High Purity RO/DI Water Skid

Shop Drawing Submittal Review

Copies	No.	Description
1 PDF	226700P01B	(Submittal No.'s:)
		(Cannon #22 6700-006) - (Paric #15051-0389) – (WES #607)
		➢ **Processed Water System - Resubmittal**

PROJECT NAME: Webster University ISB
LOCATION: St. Louis Missouri
CLIENT PROJ. No.: N/A
WES PROJ. No.: 607
SPEC SECTION: 22 6700 Processed Water System for Laboratory Facilities
SUBMITTAL ITEM:: See Below -

DESCRIPTION: 36" DIA. X 325 GALLON CONE BOTTOM- OPEN TOP

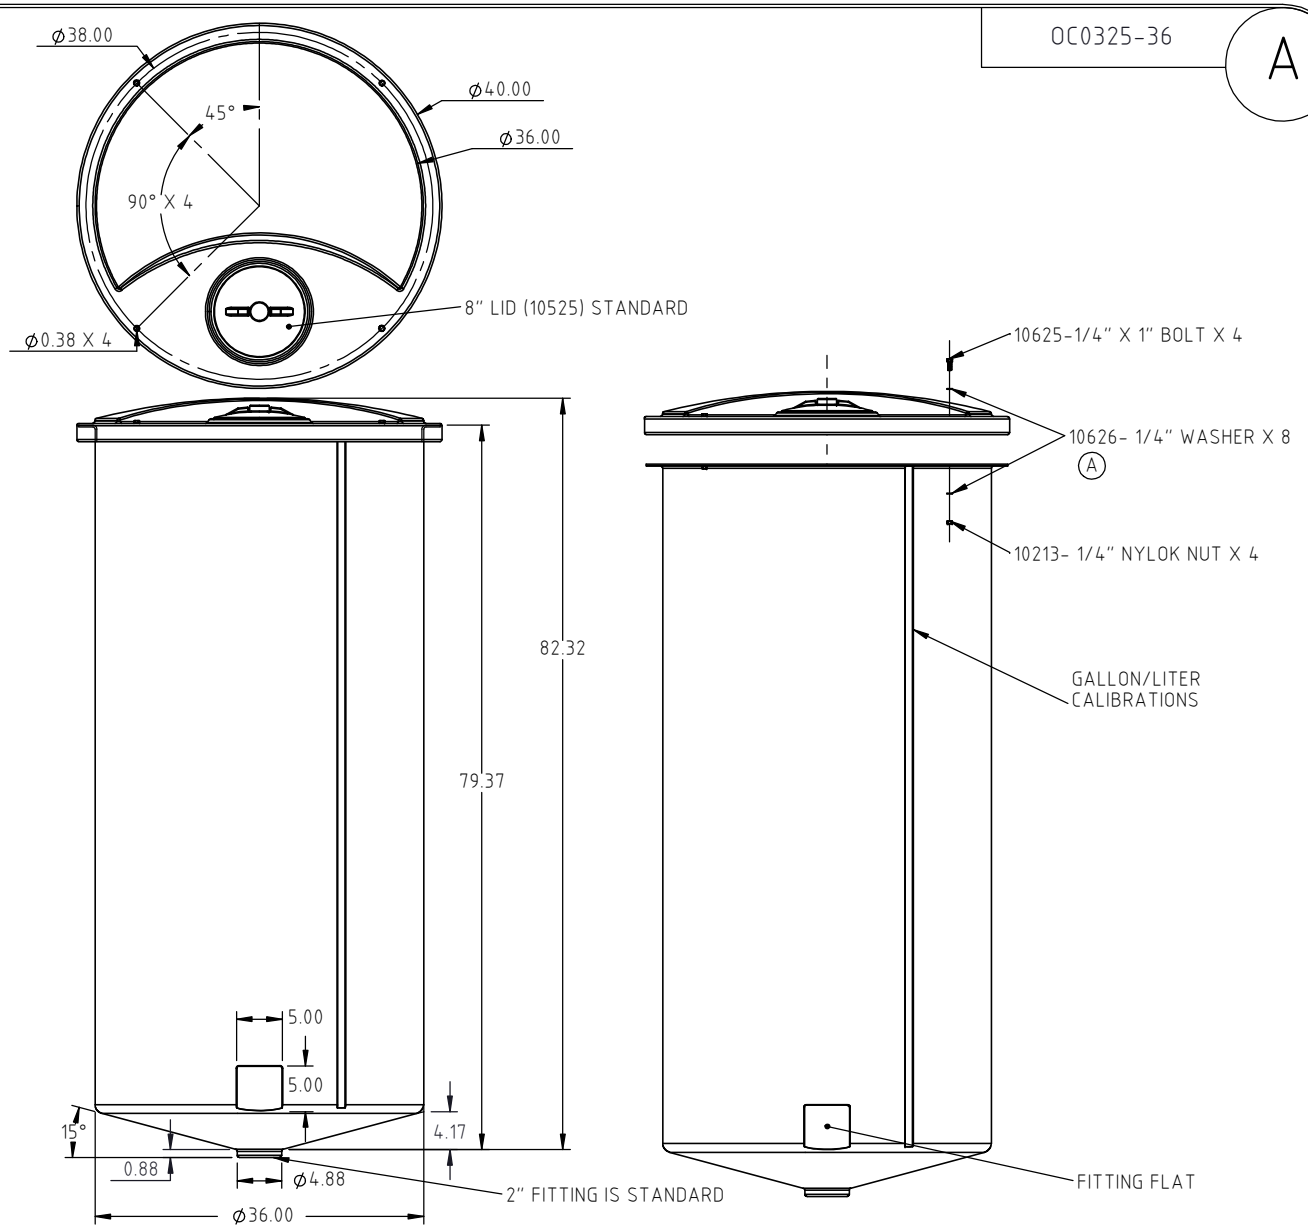
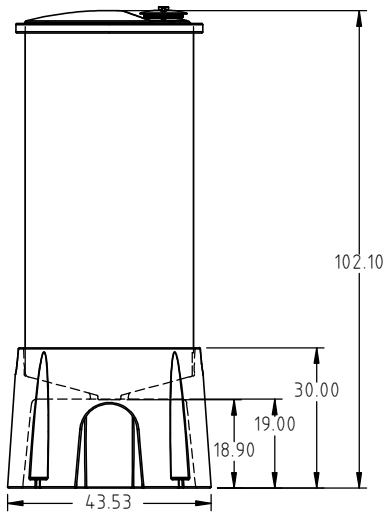
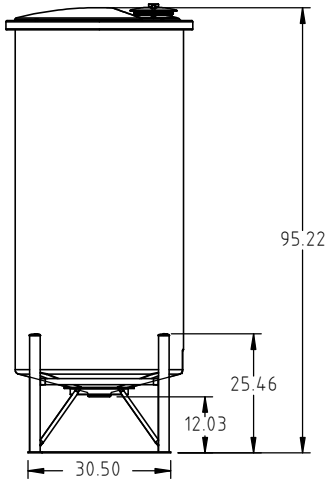
X					Pages 023 – 025 Wave Cyber DI Tank Model 14"x47"	
		X			Pages 026 – 028 Pentair Pentek Filter Housings Model – Not specified	1. Provide manufacturers model/part number and list all accessories as applicable.
X					Page 029 – 031 Water Storage Tank Den Hartog Model – 36" x 325 Gal. Cone Bottom	1. Includes – stand and vent filter assembly
		X			Pages 032 – 033 SPDT Pump Switch SJE Rhombus Model – Not Specified	1. Verify electrical rating of SPDT switch is compatible with electrical characteristics of pump.
		X			Page 034 - 035 Pressure Relief Valve Plast-O-Matic Model – Not Specified	1. Provide manufacturers model/part number.
X					Pages 036 – 048 PP Piping Georg Fischer	1. Reviewed for uses as shown on submittal page 003
		X			Page 049 – 059 Distribution Pumps Grundfos Model – CM 10-3	1. Verify correct size and capacities of pumps and motors. 2. Motor starter control panel not included in submittal. 3. Refer to specification section 226700, Pat 2.2, paragraph 7a.

DESCRIPTION: STAND FOR 15° X ø36.00". CONE BOTTOM TANK

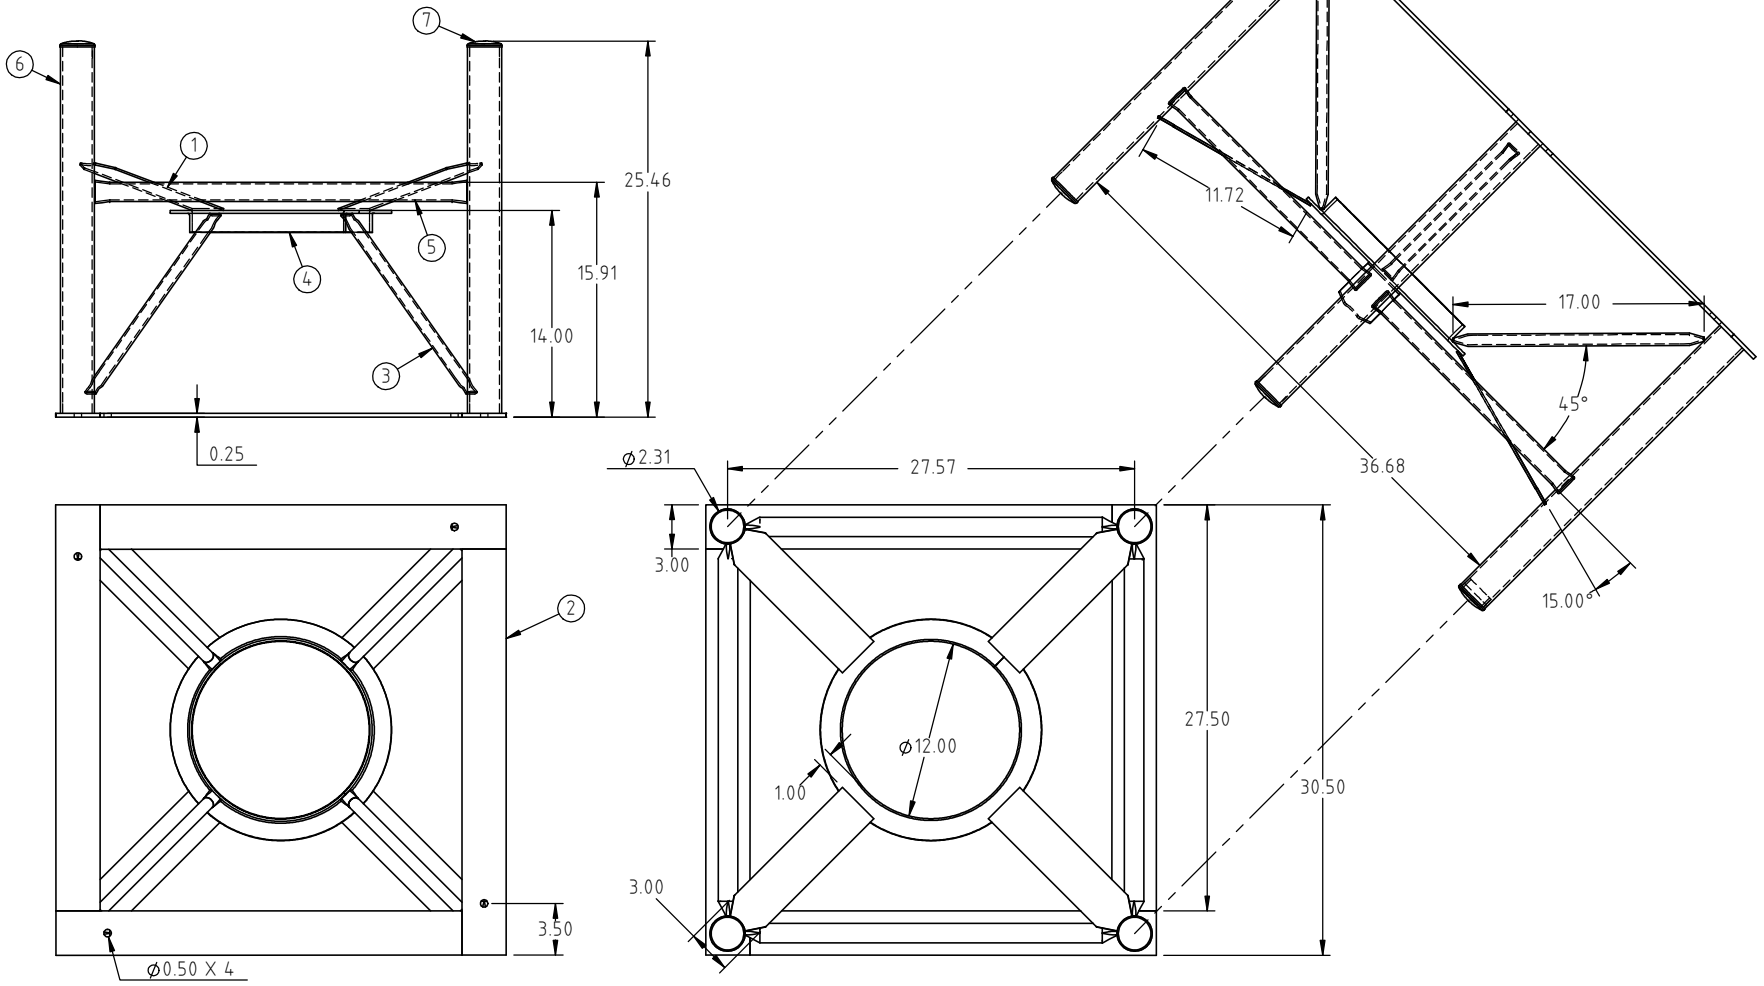
X					Pages 023 – 025 Wave Cyber DI Tank Model 14"x47"	
X					Pages 026 – 028 Pentair Pentek Filter Housings Model – Not specified	
X					Page 029 – 031 Water Storage Tank Den Hartog Model – 36" x 325 Gal. Cone Bottom	1. Includes – stand and vent filter assembly
X					Pages 032 – 033 SPDT Pump Switch SJE Rhombus Model – Not Specified	
X					Page 034 - 035 Pressure Relief Valve Plast-O-Matic Model – Not Specified	
X					Pages 036 – 048 PP Piping Georg Fischer	1. Reviewed for uses as shown on submittal page 003
X					Page 049 – 059 Distribution Pumps Grundfos Model – CM 10-3	1. Motor starter control panel not included in submittal.
X					Pages 060 – 062 Pressure Gauges PIC Gauges Model – 301LFW	
X					Pages 063 – 066 UV System Aquafine Model – CSL-4R	
X					Pages 067 – 069 Final Filter Shelco Filters Model – 5FOS3	
X					Pages 070 – 074 Conductivity/Resistivity Sensor Georg Fischer Model Signet 2850
